# Big Eddy Small Hydropower Project Public Update Meeting

Dr. G. Alan Hepburn, P.Eng.  
May 17, 2011

# Re-aligned Tailrace

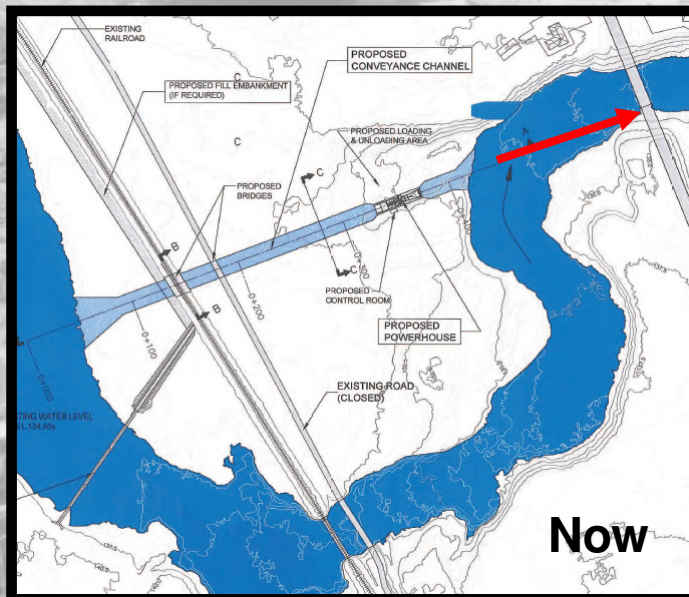
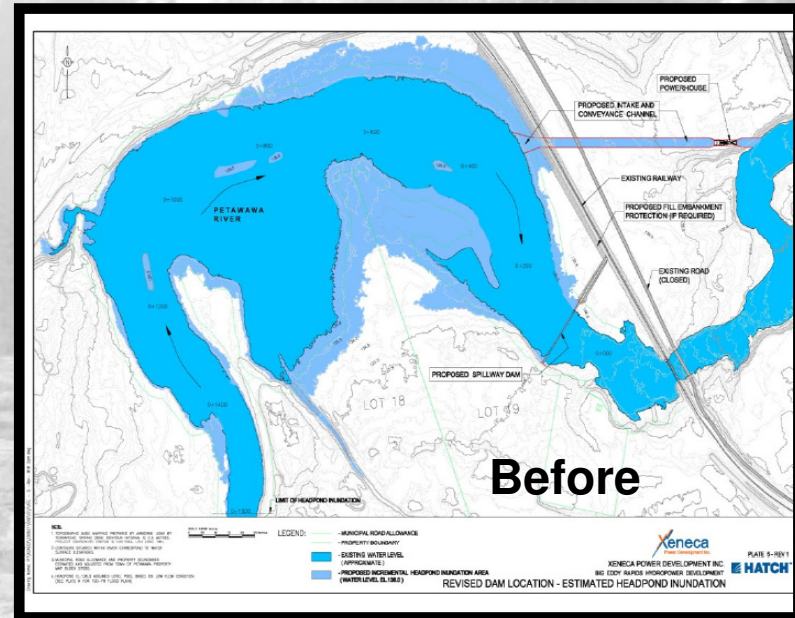
- The diagram below shows the alignment presented to the PEO in Deep River
- It still may not be enough to avoid erosion

# Flow Report Numbers

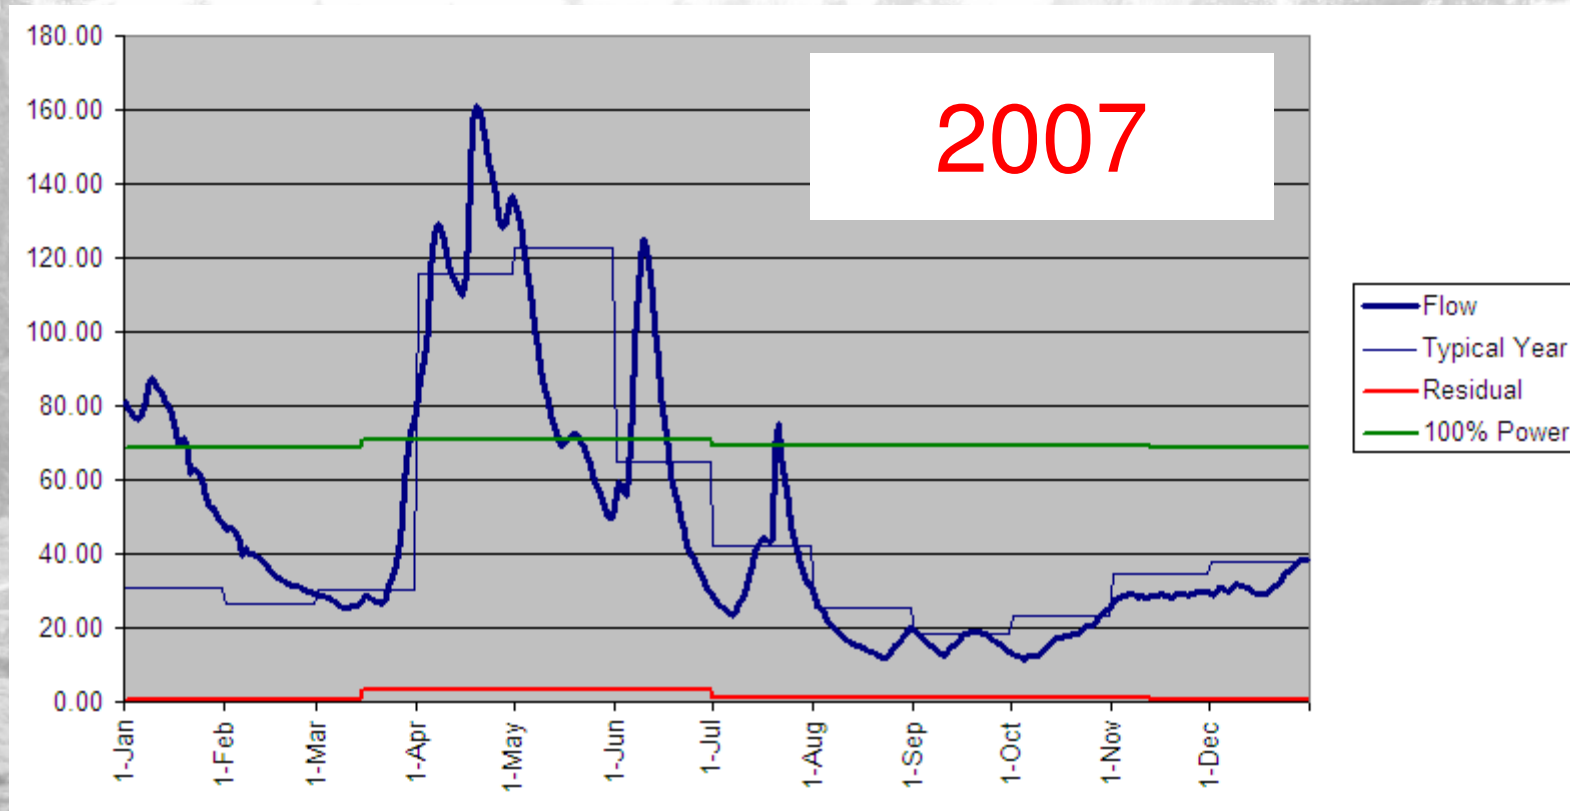
- 2007 was a fairly typical year
  - 2010 was very dry, so we don't want to be accused of using these numbers to distort the story
- They can't use flow above green line
- Shut down below 20.4 (most of summer)

# Upstream Flooding

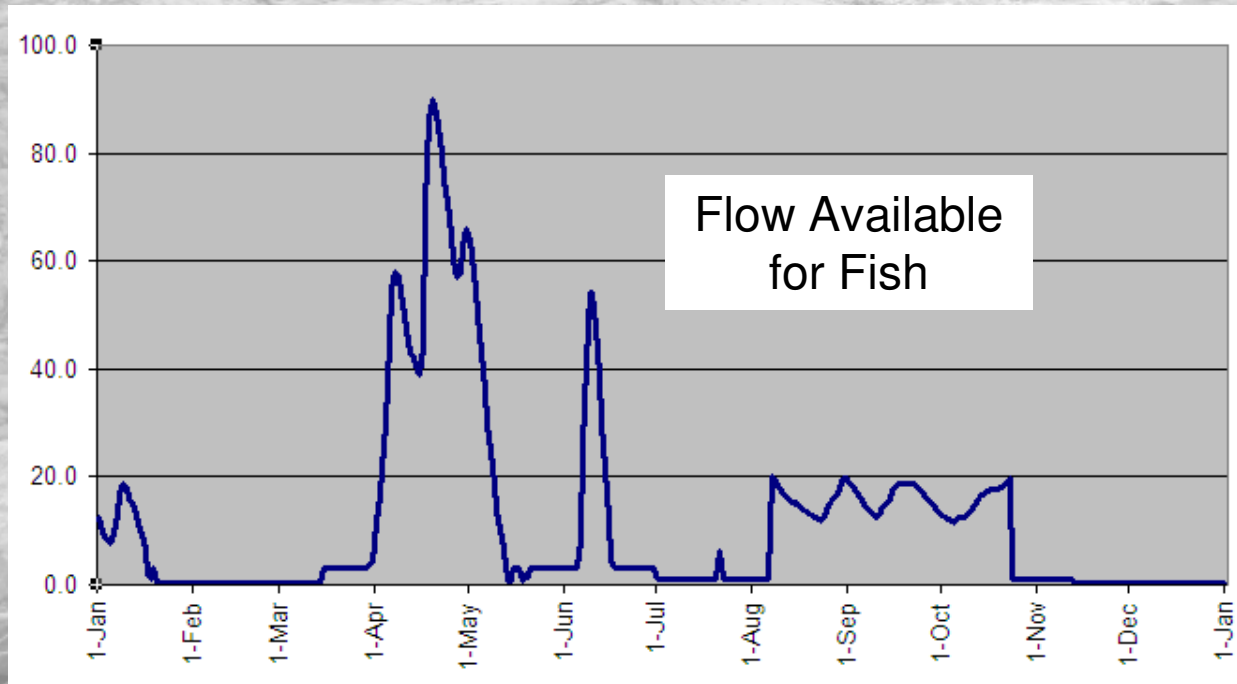
- We have no information about this “section of the weir that can be lowered”
  - It is probably not automatic, like the earlier “Obermeyer Gates”
  - How will it affect kayakers?
- No indication that the effects of ice, debris have been considered

# Fish Spawning Area

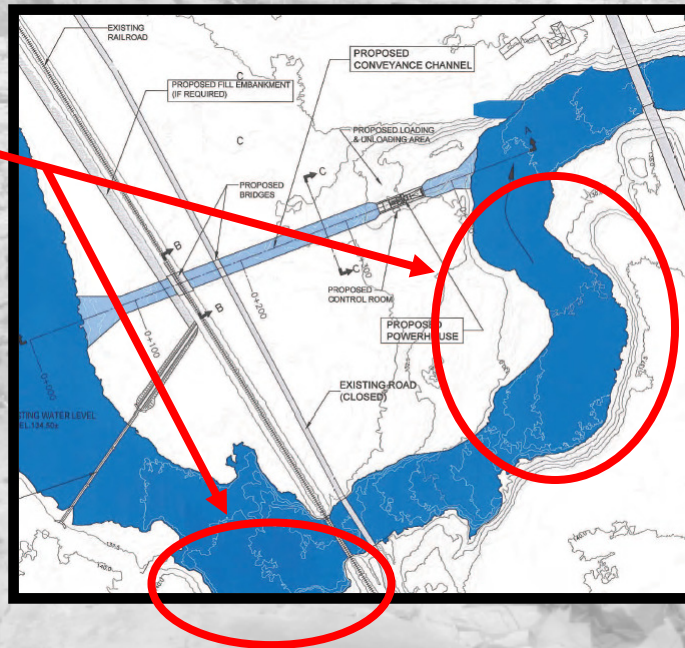
- Most likely areas are here
- What can mitigate 1 m<sup>3</sup>/sec?

# Public Safety

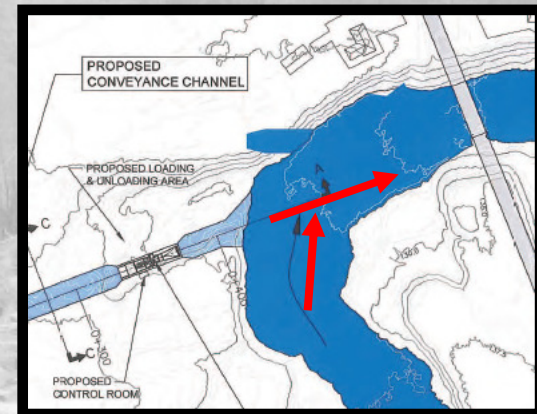
- Have no information on these safety systems
  - As usual, our request for information has been ignored
  - Enhancing public awareness using signs, sirens and flashing lights does not seem appropriate in a high-use area
  - Here come the fences!

# Xeneca PIC, May 5

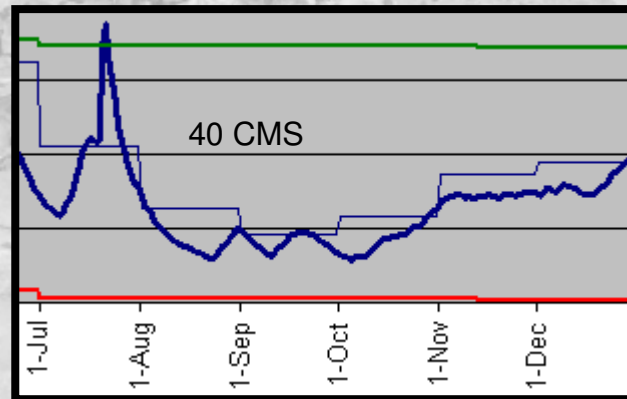
- It's a dam! It's a weir! It's a "Naturalised Passage"!
- Example from Calgary is not a power generation facility
  - Nothing like 2 metres of head
  - Flow shown was 40 m<sup>3</sup>/sec
  - In summer, there isn't that amount of water in the river
